Staff Summary Report

Development Review Commission Date: 05/11/10

SUBJECT: Hold a public meeting for a Development Plan Review for ELLIOT BUSINESS PARK – PHASE 3 located at 7825 S. Hardy Drive.

DPR10041 – Development Plan Review including site plan, building elevations, and landscape plan.

DRB Submittal Only - Not for Construction
Building 5 - Exterior Elevations
 Elliot Business Park
 7805 - 7929 South Hardy Drive
 800 Carver Road
 Tempe Marketplace Commerce Associates
 4-29-2010
 Architects

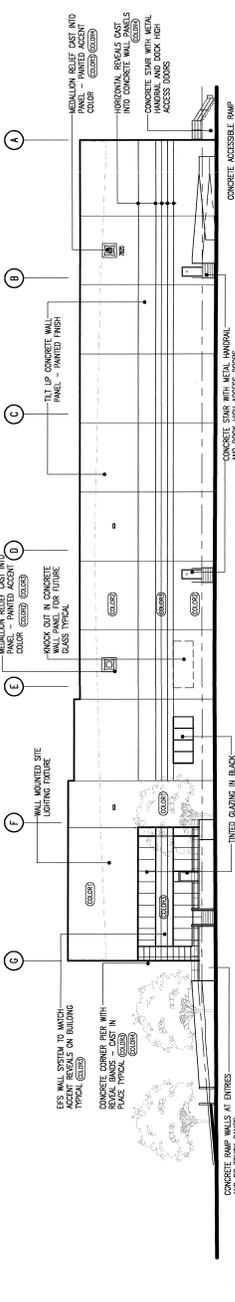
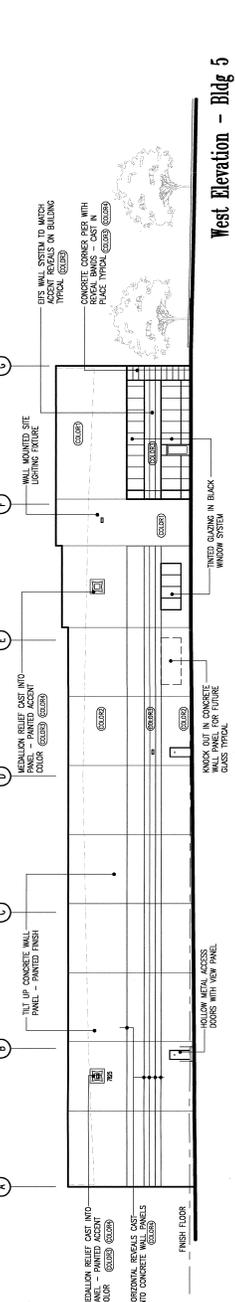
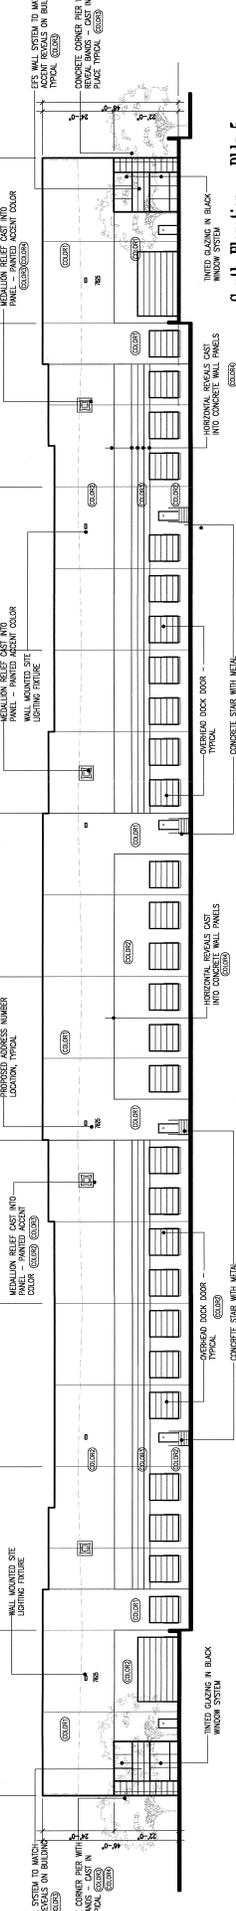
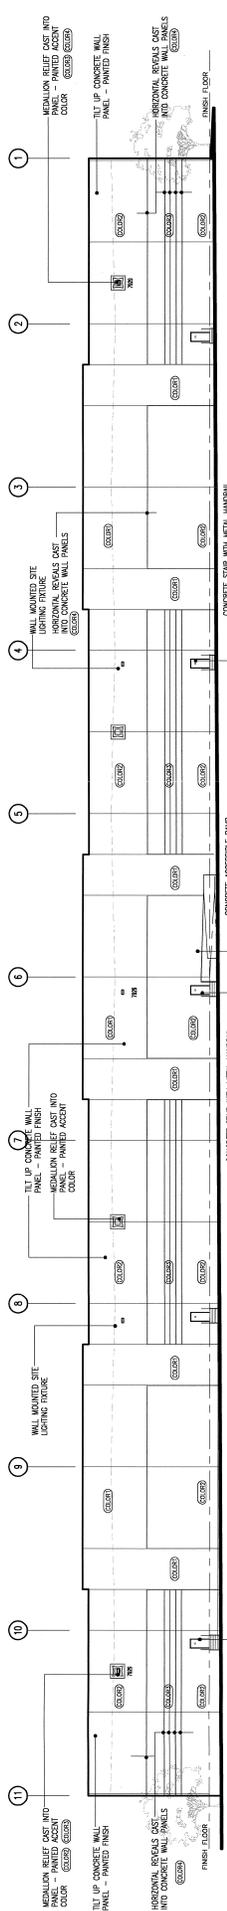
7. The materials and colors are approved as presented:
 - Tilt up Concrete Wall Color 1 – Paint – Sherwin Williams 2214 Ivory
 - Tilt up Concrete Wall Color 2 – Paint – Sherwin Williams 2212 Headlands

- EIFS Wall System Decorative band and column– Color 3 Paint – Sherwin Williams 2216 Adano Bronze
 - EIFS Wall System Reveal – Color 4 Paint – AC141N Domino

- Tinted glazing in black window systemProvide main colors and materials with a light reflectance value of 75 percent or less. Specific colors and materials exhibited on the materials sample board are approved by planning staff. Submit any additions or modifications for review during building plan check process.

8. Provide secure roof access from the interior of the building. Do not expose roof access to public view.
 9. Conceal roof drainage system within the interior of the building or minimize visible, external features, such as overflows, and where needed design these to enhance the architecture of the building.

10. Incorporate lighting, address signs, and incidental equipment attachments (alarm klaxons, security cameras, etc.) where exposed into the design of the building elevations. Exposed conduit, piping, or related materials is not permitted.

12. Do not use divided glazing panels in exterior windows at grade level, where lower (reachable) glass panes of a divided pane glass curtain-wall system can be reached and broken for unauthorized entry. Do not use landscaping or screen walls that conceal area around lower windows. If this mullion pattern is desired for aesthetic concerns, use laminated glazing at these locations.

Sheet Number: L-1

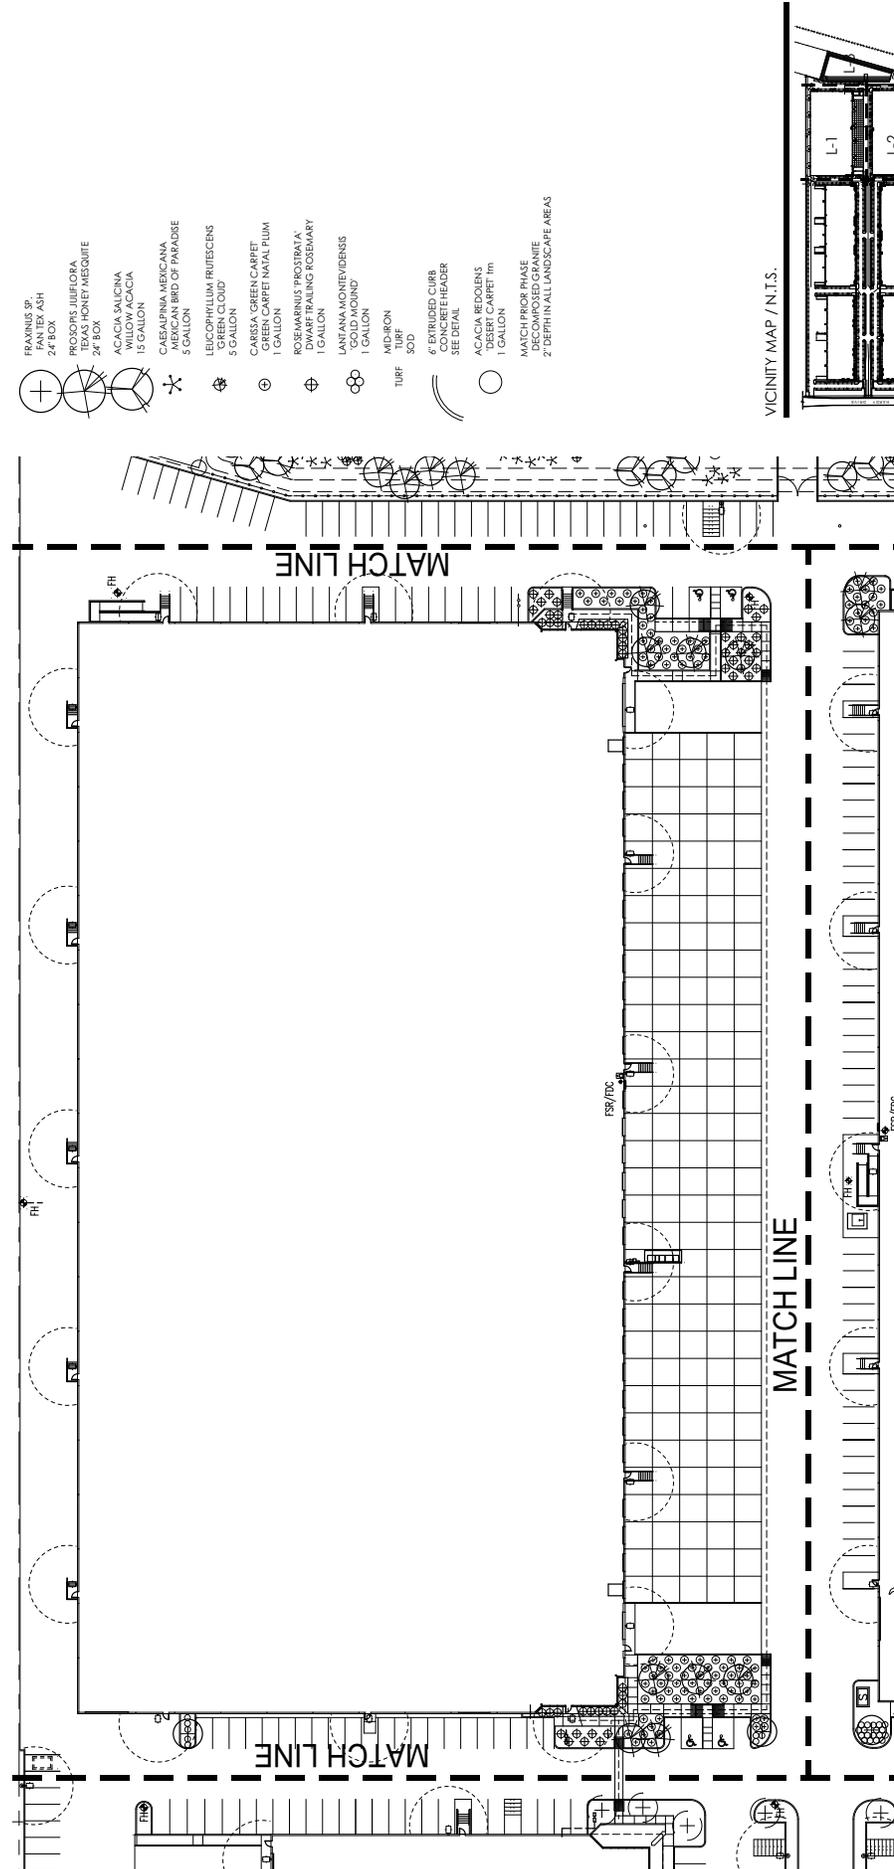
15. Replace any dead or missing trees on the property.
16. The plant palate is approved as proposed and specified on the landscape plan. Any additions or modifications may be submitted for review during building plan check process.

17. Irrigation notes:
 - a. Provide dedicated landscape water meter.
 - b. Provide pipe distribution system of buried rigid (polyvinylchloride), not flexible (polyethylene). Use of schedule 40 PVC mainline and class 315 PVC ½" feeder line is acceptable. Class 200 PVC feeder line may be used for sizes greater than ½" (if any). Provide details of water distribution system.

18. Include requirement to de-compact soil in planting areas on site and in public right of way and remove construction debris from planting areas prior to landscape installation.

19. Top dress planting areas with a rock or decomposed granite application. Provide rock or decomposed granite of 2" uniform thickness or less. Provide pre-emergence weed control application and do not underlay rock or decomposed granite application with plastic.
